ENCLOSURE 1
RESPONSES TO DPE QUERIES

Moolarben Coal Complex – Open Cut Optimisation Modification

Response to NSW Department of Planning and Environment Information Request

Figure 1

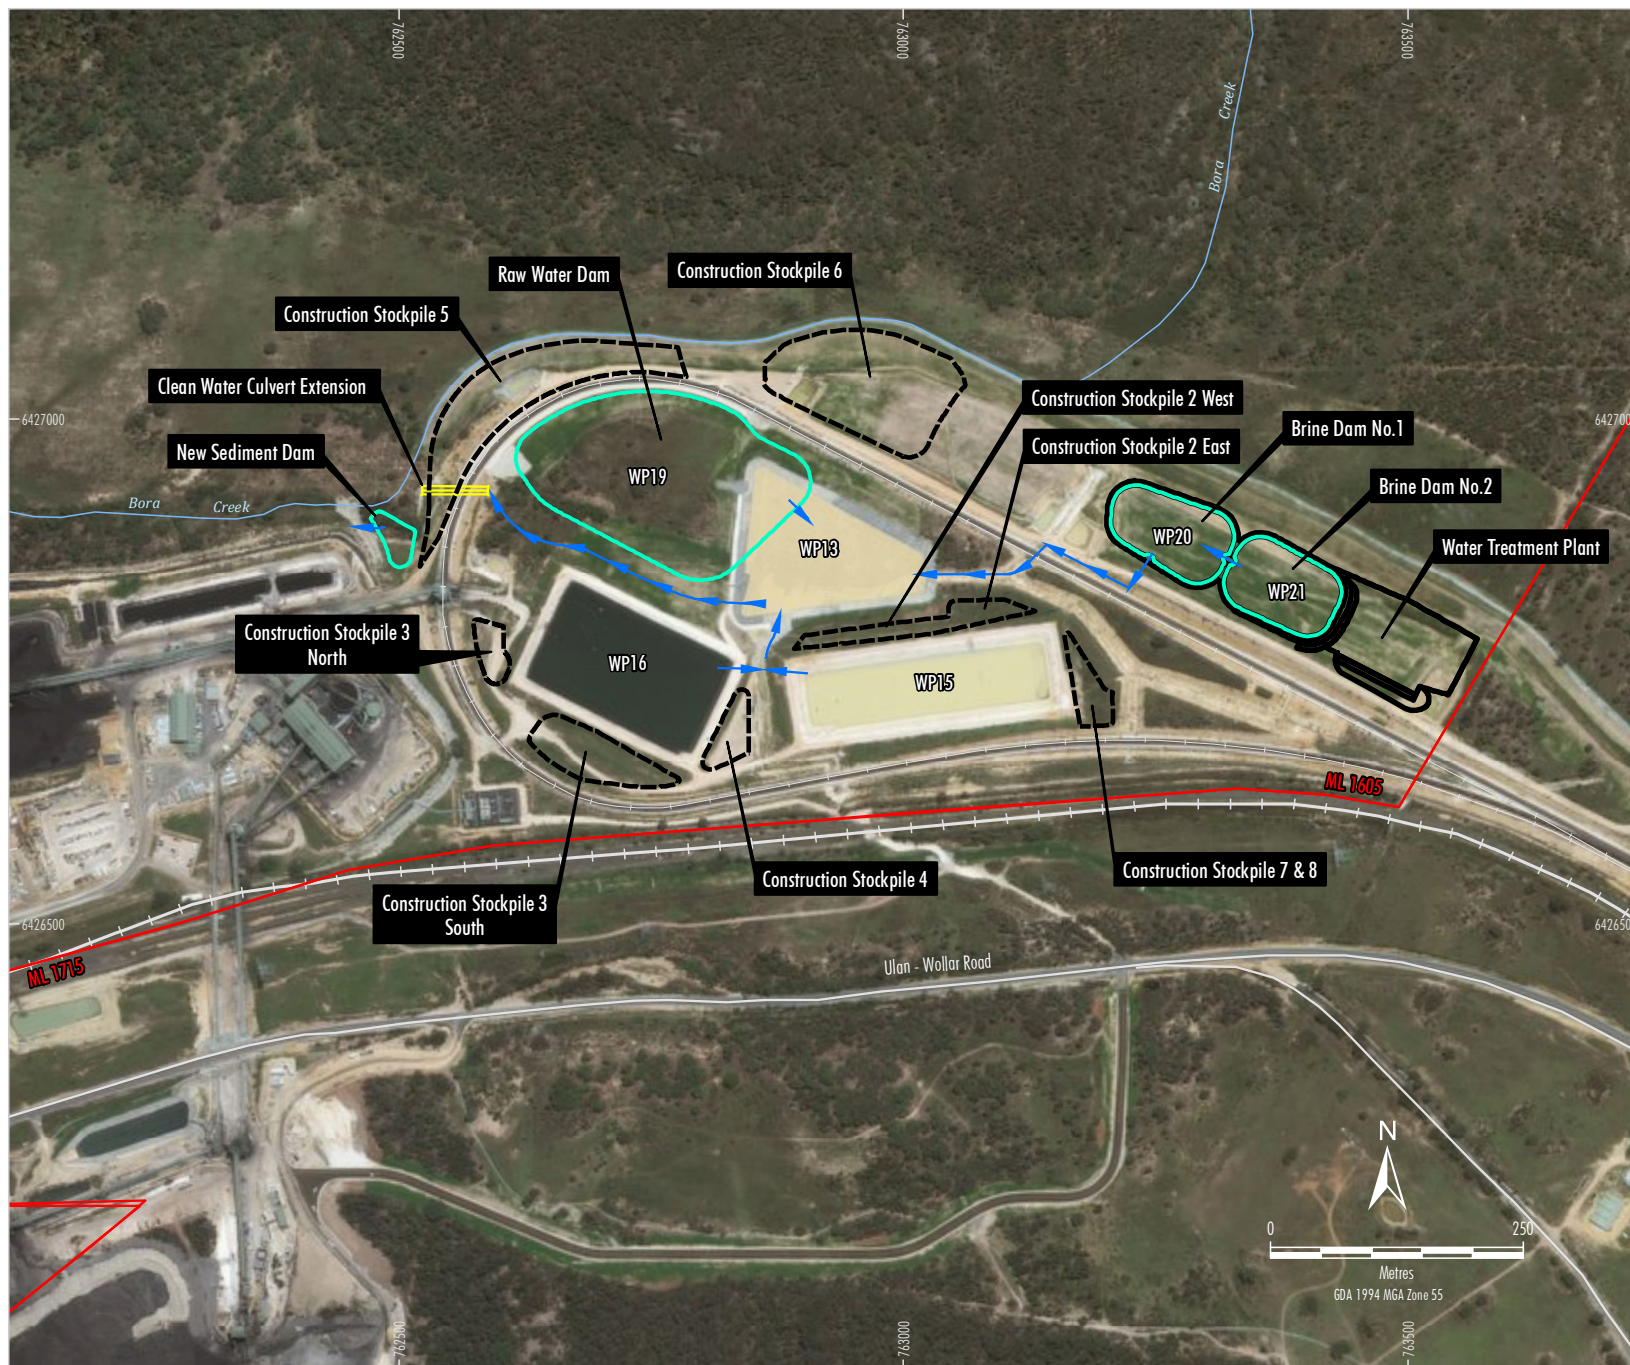
Provide more detailed information on the design and layout of the water treatment facility (WTF) and associated storages. It is understood that the WTF would be located within and adjacent to the rail loop, which is a relatively constrained area in close proximity to Bora Creek. Layout mapping, showing the number and area of pre-treatment and by-product storages and overflows to existing storages, should be provided. This information should be in a larger scale than that presented in Figures 4.1 to 4.5 of the WRM 2017 report (Appendix E of the EA).

Figure 1 presents the general design and layout of the proposed water treatment facility.

MOOLARBEN COAL COMPLEX MINING OPERATIONS PLAN – PLAN 3B

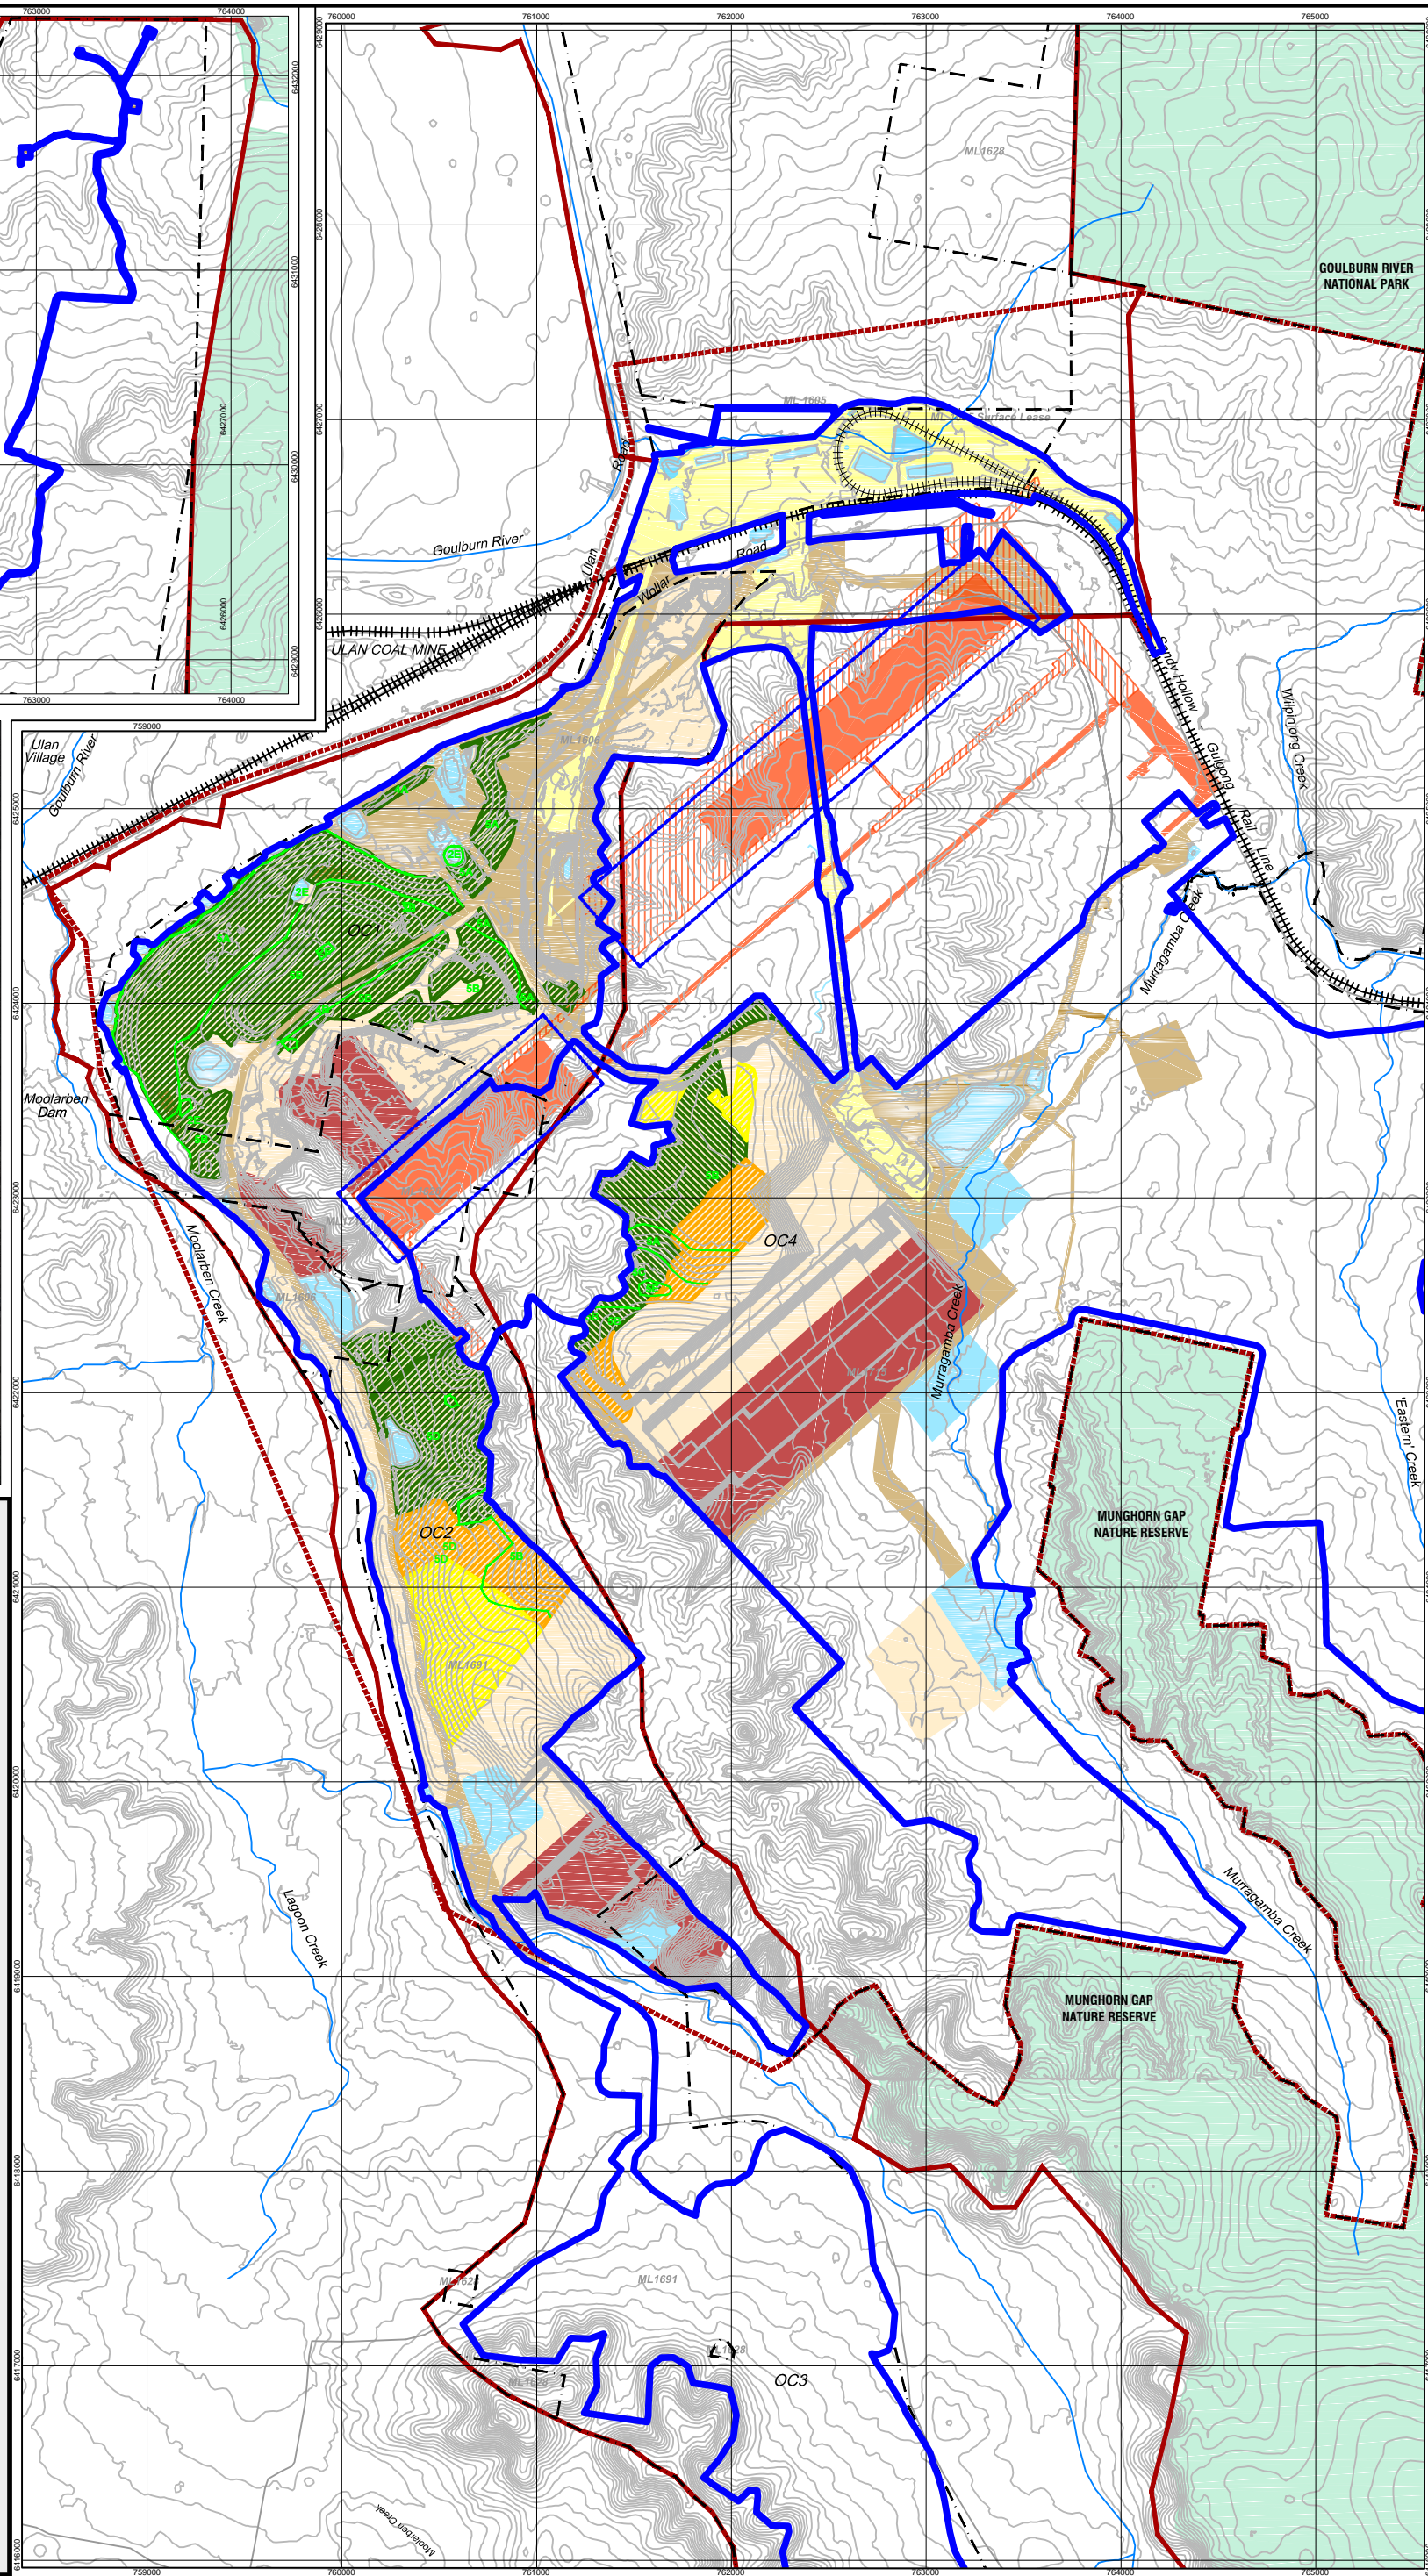
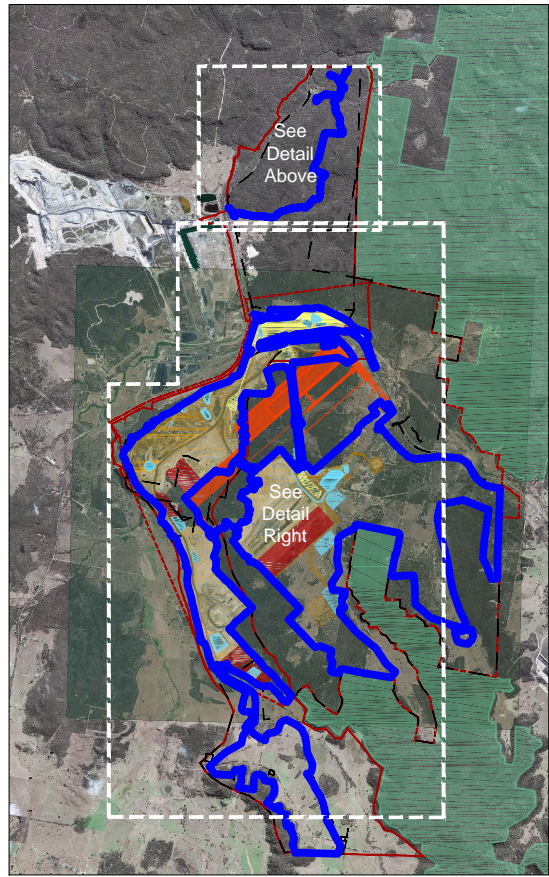
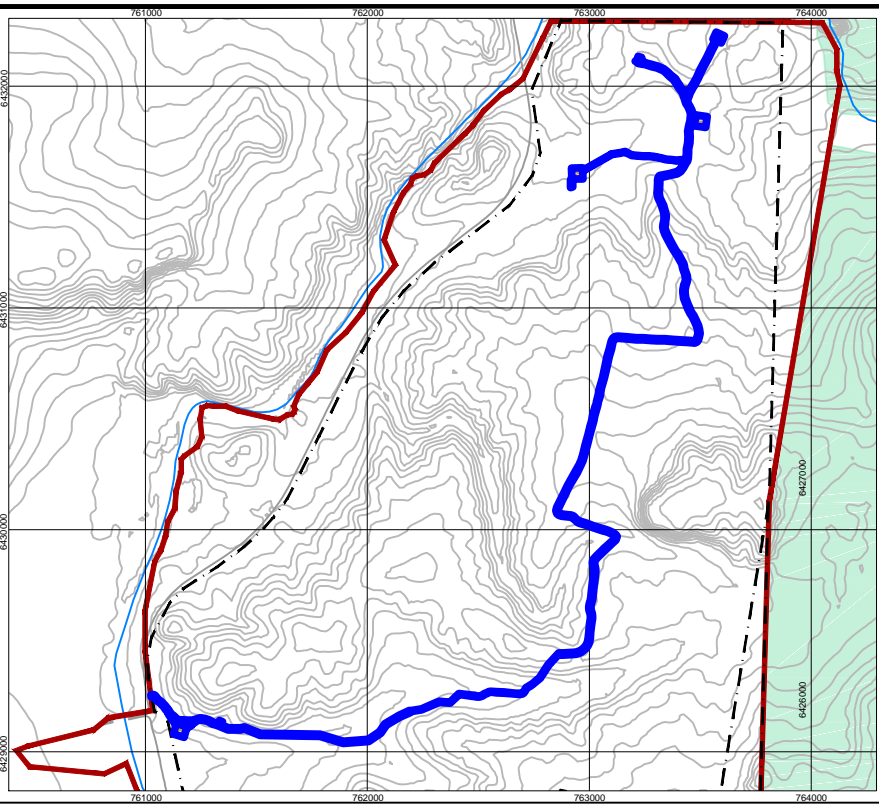
- *the status of mining operations in each open cut and underground mining domain;*
- *the status of operations in the Stage 2 surface facilities;*
- *the location extracted coal from each domain is being processed (ie. Stage 1 or Stage 2 surface facilities); and*
- *a summary of the future mining schedule.*

Figure 3B from the current Moolarben Coal Complex Mining Operations Plan (MOP) is provided in Attachment 1 and provides the planned mining operations and rehabilitation to 31 December 2018. Open cut extraction is currently taking place in OC1, OC2 and OC4, with underground extraction from UG1.
